ADDENDUM NO. 1

Request for Proposals (RFP) – Vendor Questions and Responses

Atrium Acoustics Remediation Project

Howard Miller Public Library

Library second floor with Study Area outlined in yellow.

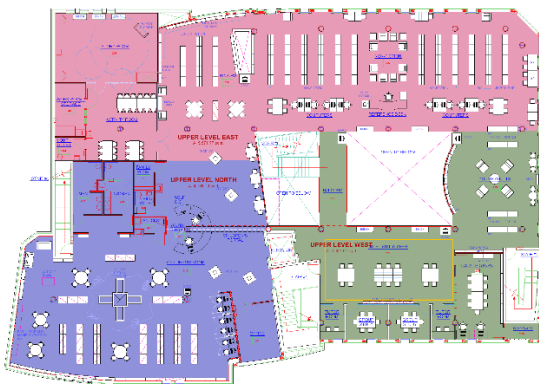
What is the official area of the "Quiet Study Area" on the second floor by the Study Rooms that requires ceiling tile replacement? There will be an obvious break between newer and older tiles.

The area requiring ceiling tile replacement is defined as the space extending:

- From the prefabricated wall of the Study Rooms to the hanging light fixtures; and
- From the wall of the Work Room to the wall containing the stairwell door.

This area defines the intended limits of the ceiling tile replacement work. See image below with area highlighted in yellow rectangle.
